complete guitar wiring: erratum

Chapman ML3 Pro Modern (HH)

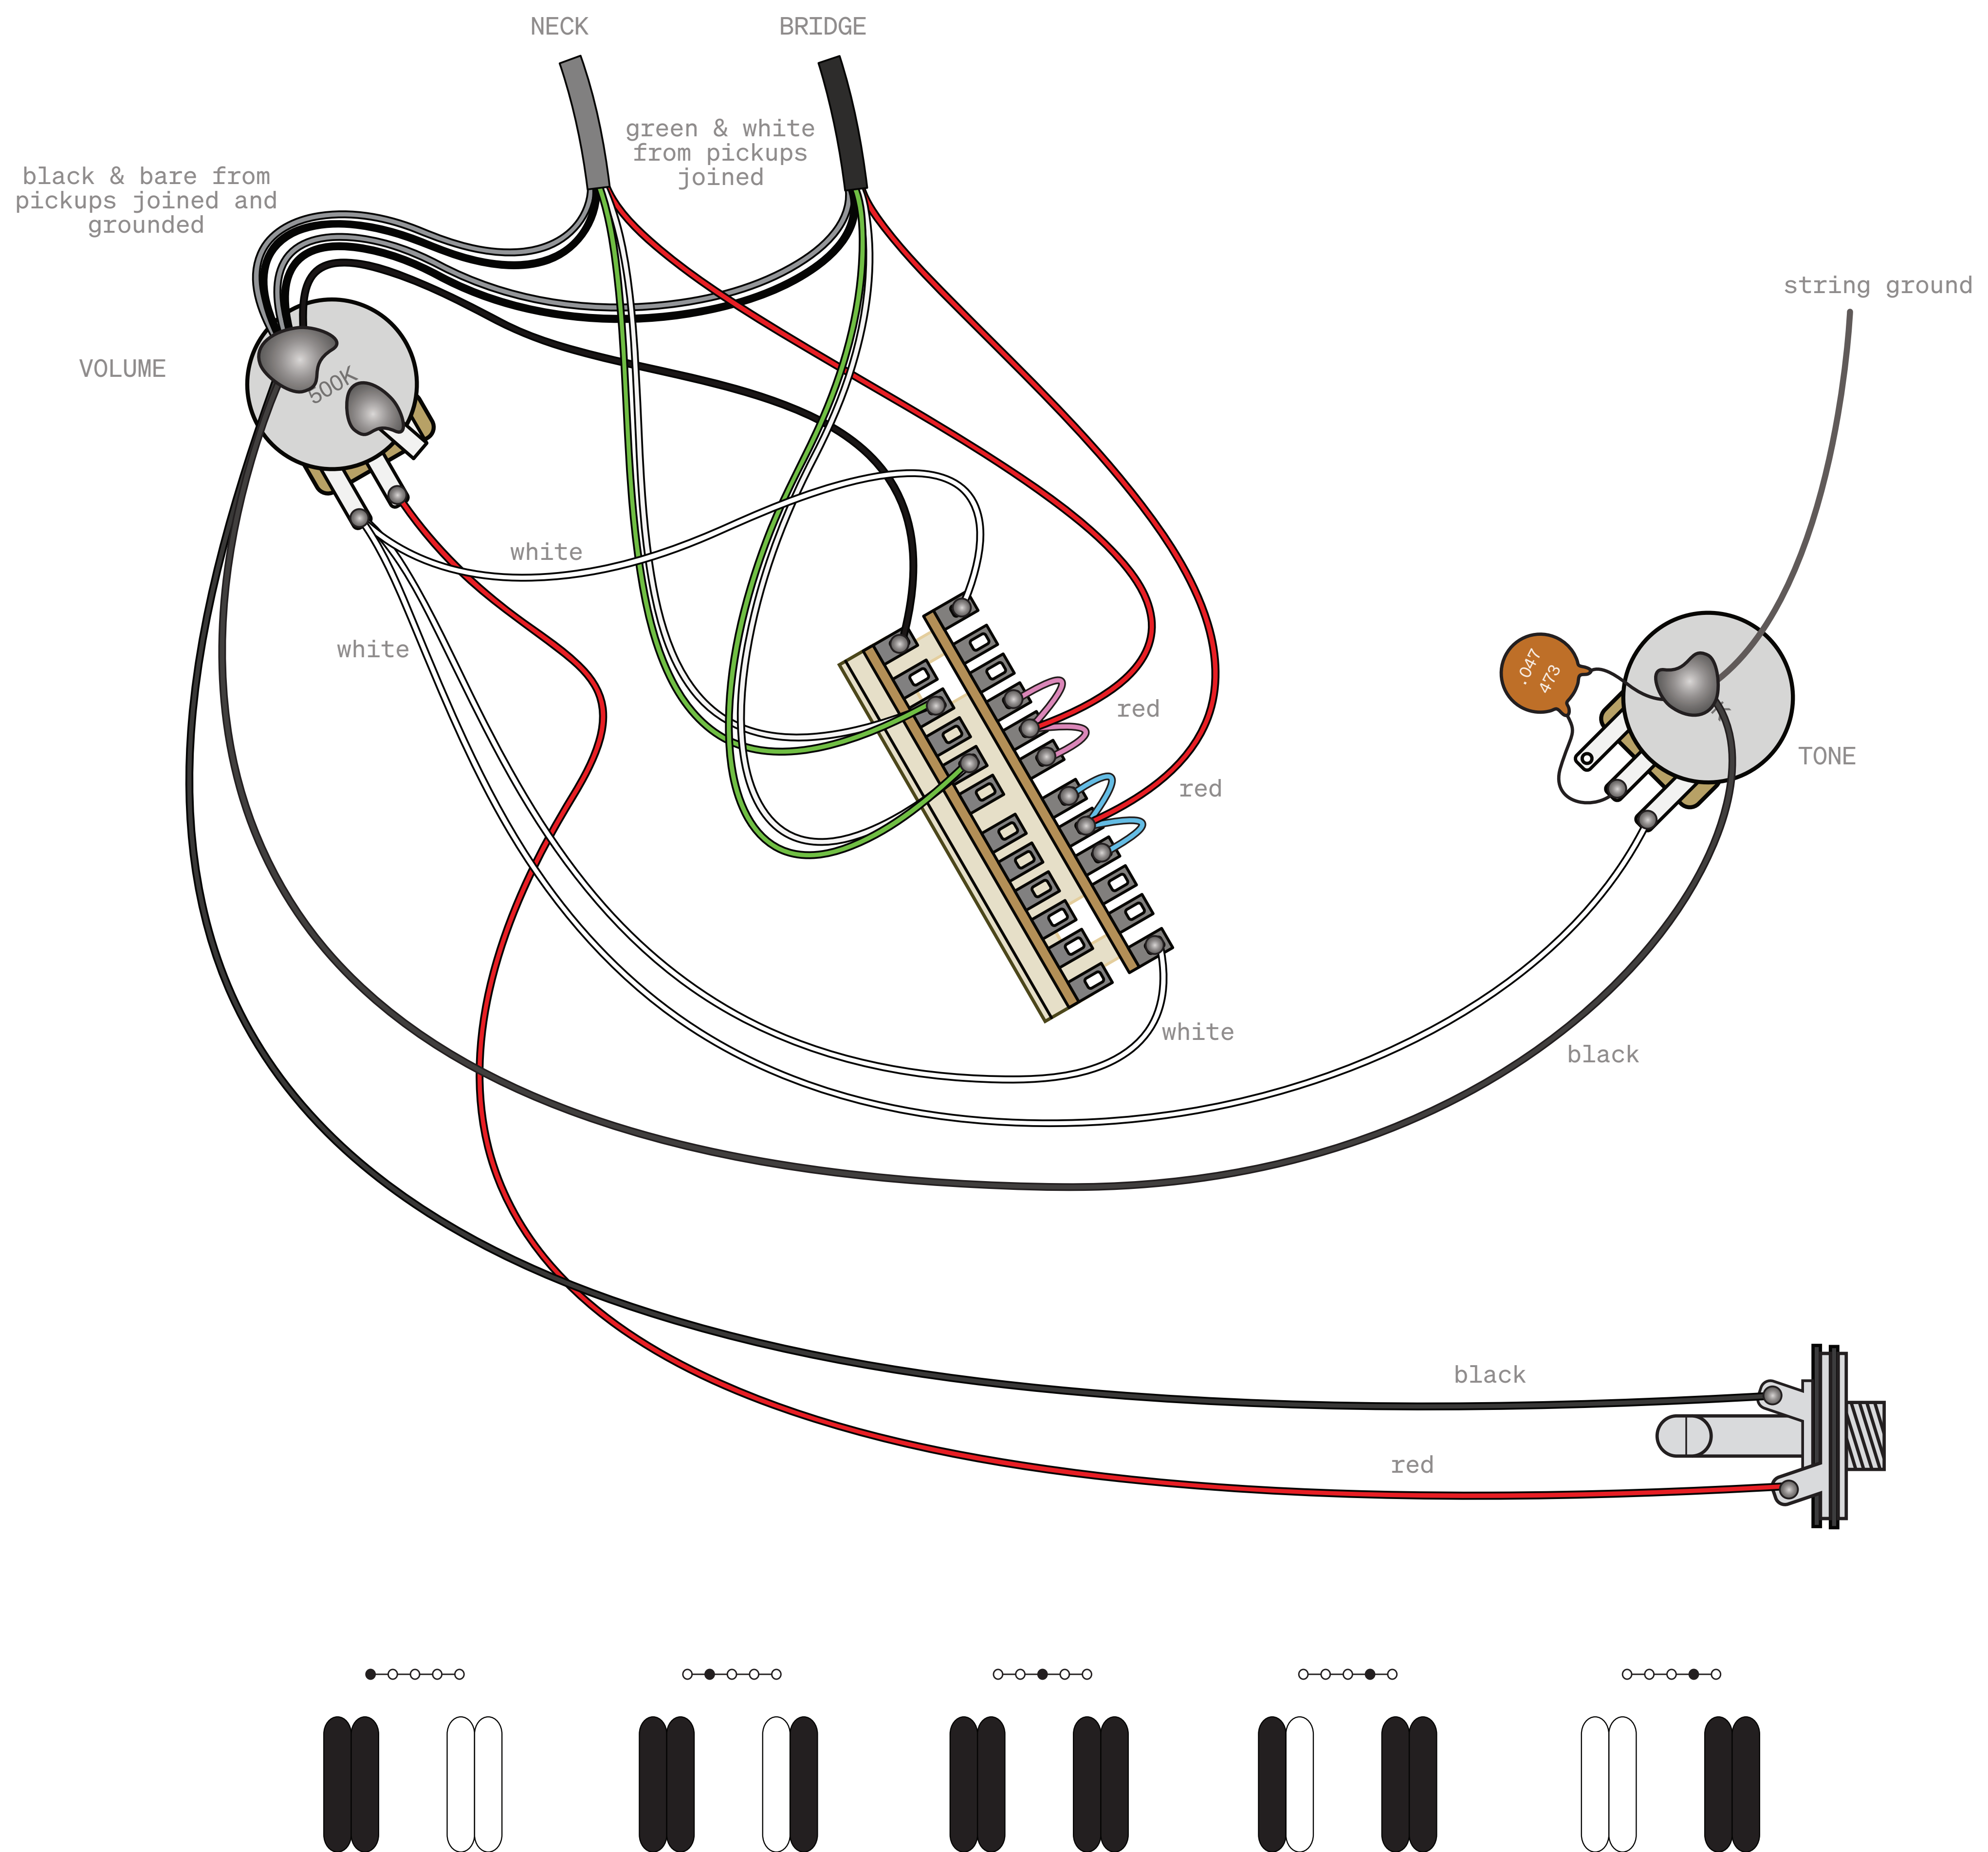
Page 200. Original diagram omitted switch jumper wires for pickup hots (shown here blue and pink).

volume: 500K
tone: 500K
tone capacitor: 0.047 μ F
switch: 5-Way Super Switch
